Power Equipment

CODE: CC-271

DATE: FEBRUARY 6, 1994

SUBJECT: BRAKE PEDAL AND DRIVE PEDAL BOLTS BREAKING ON 2135 TRACTORS. SERIAL NUMBER 239301-241640.

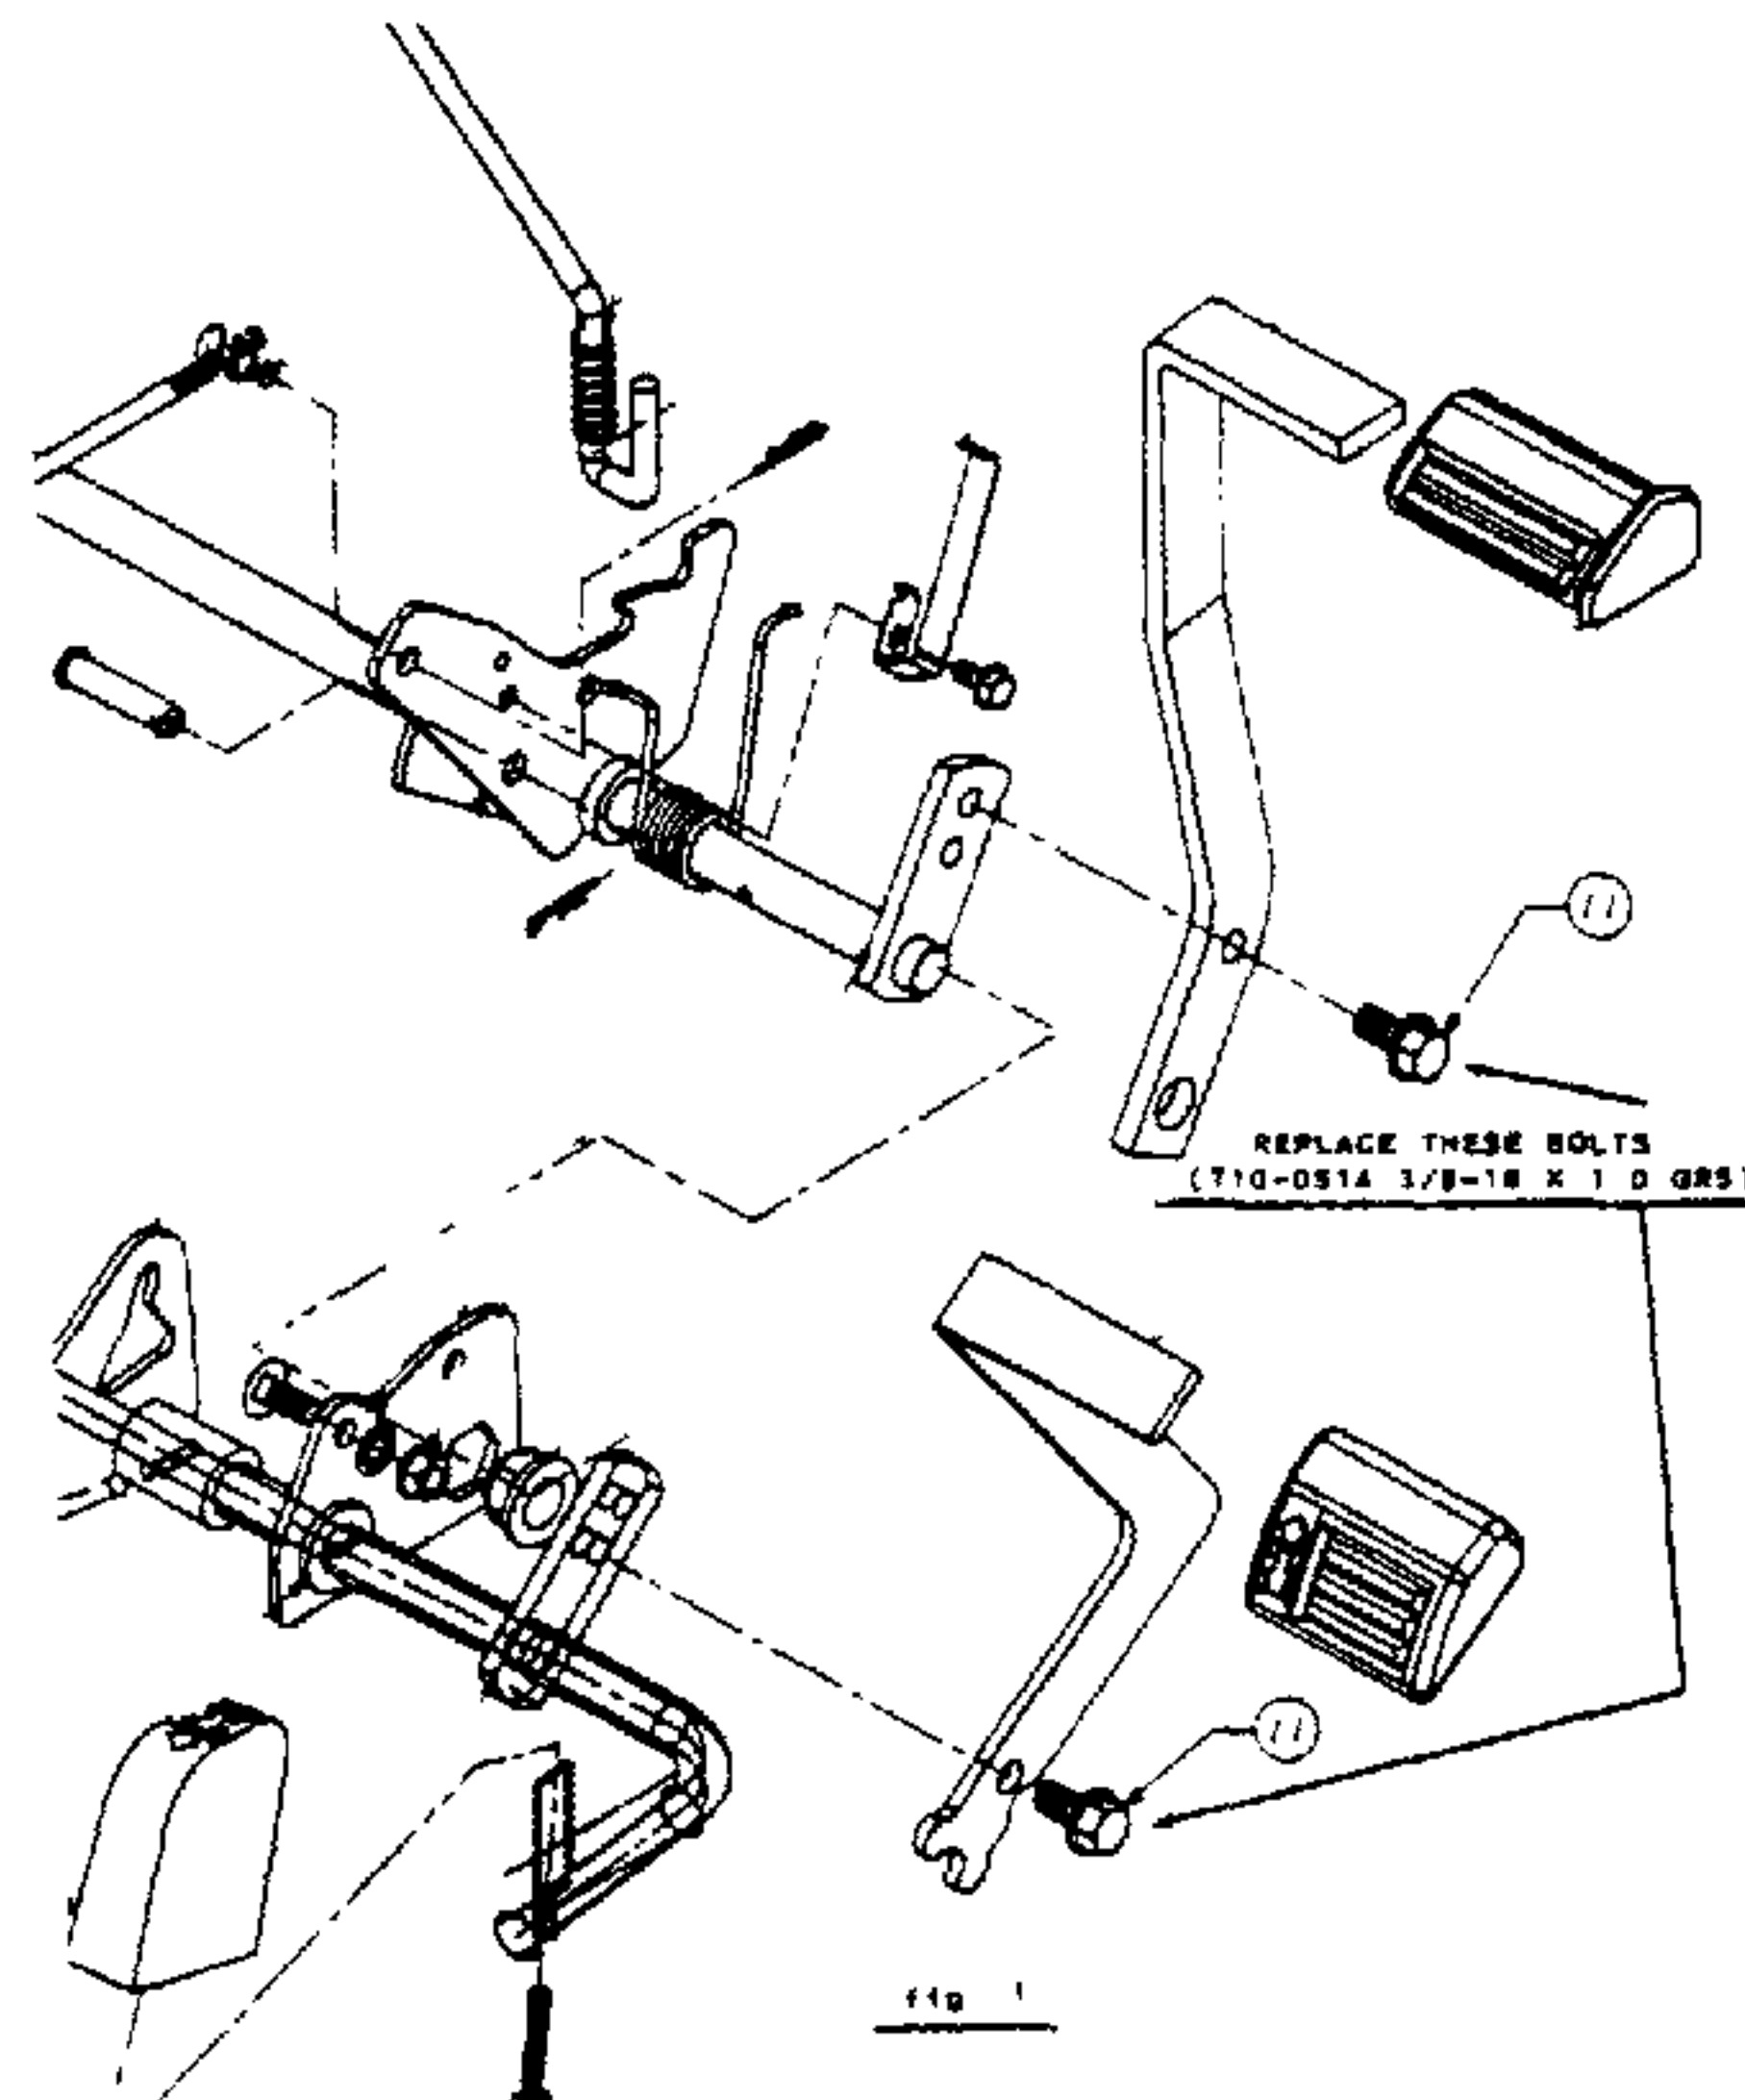
The bolts used to secure the brake pedal and forward drive pedal to their respective cross shafts may break. The process used to zinc plate the bolts may have been missed by the manufacturer causing them to be brittle.

Replace the bolts mentioned above (see fig. 1), using the part number suggested or, an existing bolt from your parts stock that meets grade 5 specifications.
